Access Compliance Report

Public Rights-of-Way

(Curb Ramps)

Intersection ID: 43350	Main Street: FORESTRIDGE COMMONS DR	Cross Street: PROSPERITY COMMONS DR	Location: S
ADA ID: 1E09962DA166	Ramp Type: PerpDiag	Initial Pass/Fail: Fail	Overall Compliance: No
Severity Score: 22.5			
Codes/Mitigation Info/Possible Solution		Field Measurements/Component Compliance

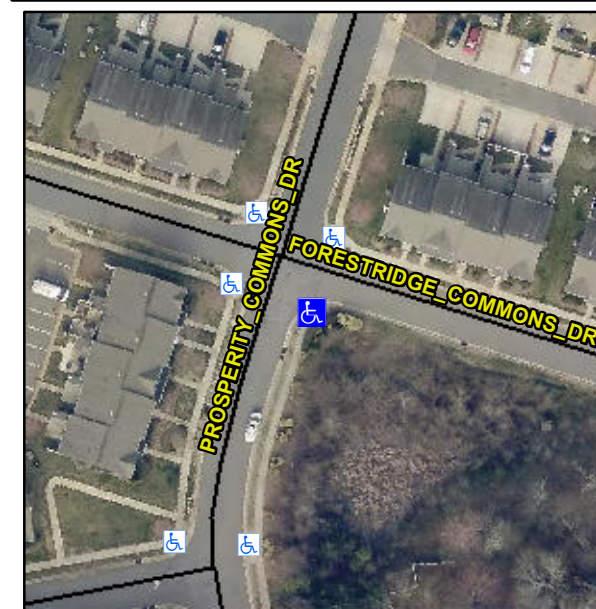
Remove & Replace Curb Ramp With Two New Directional Ramps or Equivalent.

R304.5.1, R304.2.2, R304.5.3

Compliance	Description	Data	Compliance	Description	Data
N/A	Ramp Length (in)	47.0	No	Ramp Slope (%)	9.2
No	Ramp Width (in)	41.0	No	Ramp XSlope (%)	2.9
N/A	Flare Type LT	N/A	N/A	Flare Type RT	N/A
N/A	Flare Slope LT (%)	N/A	N/A	Flare Slope RT (%)	N/A
N/A	Flare Traversable LT?	N/A	N/A	Flare Traversable RT?	N/A
N/A	Landing Length (in)	N/A	N/A	DWS Provided?	N/A
N/A	Landing Width (in)	N/A	N/A	DWS Contrast?	N/A
N/A	Landing Slope (%)	N/A	N/A	DWS Length (in)	N/A
N/A	Landing X Slope (%)	N/A	N/A	DWS Full Width?	N/A
N/A	Landing Curb? (Y/N)	N/A	N/A	DWS Offset (in)	N/A
N/A	Shared Landing?	N/A			
N/A	Gutter Ponding?	N/A	N/A	Gutter Slope (%)	N/A
N/A	Gutter Lip Ht (in)	N/A	N/A	Gutter X Slope (%)	N/A
N/A	Painted X Walk1?	No	N/A	Painted X Walk2?	No
	X Walk 1 Direction	To NE		X Walk 2 Direction	To NW
N/A	X Walk 1 Width (in)	N/A	N/A	X Walk 2 Width (in)	N/A
	X Walk 1 Slope (%)	1.3		X Walk 2 Slope (%)	4.8
	X Walk 1 X Slope (%)	4.7		X Walk 2 X Slope (%)	1.0
